FIRE SAFETY INSPECTION REPORT

Shinest Apparels Ltd. (Extension)

Date: 8 August 2023

Table 1. Findings And Recommendations

F-10 Fire Rated Construction

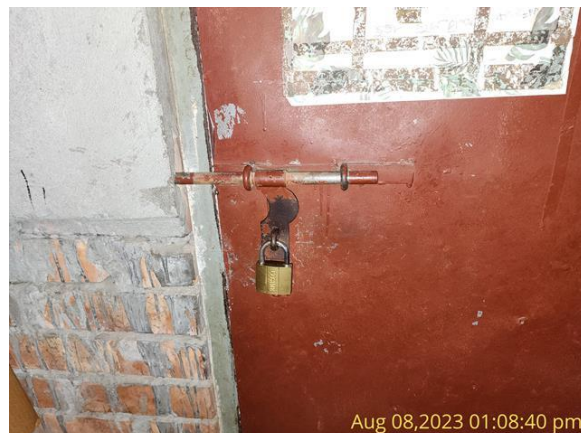
Unsealed penetrations and openings are located in exit stair enclosures and separation walls. (Building 2 and 3)

Seal all penetrations and openings in exit stair enclosure and separation walls to maintain the required fire separation. Penetration is prohibited into and through an exit enclosure. Re-route the cable channels.

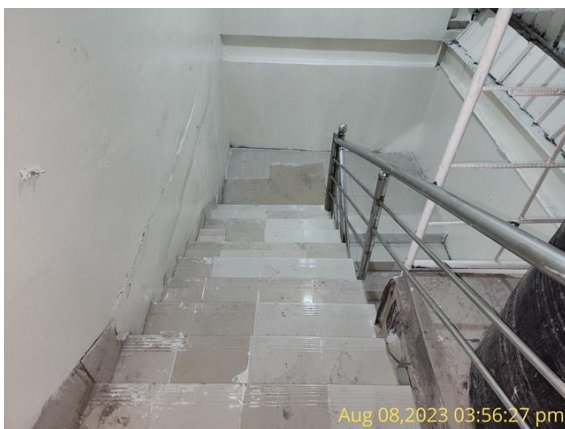
F-23	Egress	Dead-end distance exceeds 15 m (50 ft) limit at building 4.	Reconfigure the egress arrangement to reduce the maximum dead-end distance to not more than 15 m (50 ft) in accordance with RSC 6.13.3.	Within 3 months
F-24	Fire Rated Construction	The exit stairwell stairs are non-rated and not enclosed in fire rated construction due to non rated beam, column and deck slab. (Building-2).	Provide 2-hr fire rated stairwell enclosure on each floor level. Or Provide 2-hr fire rated coating on the steel structural materials to meet RSC 6.3.1.2.2.	Within 6 months
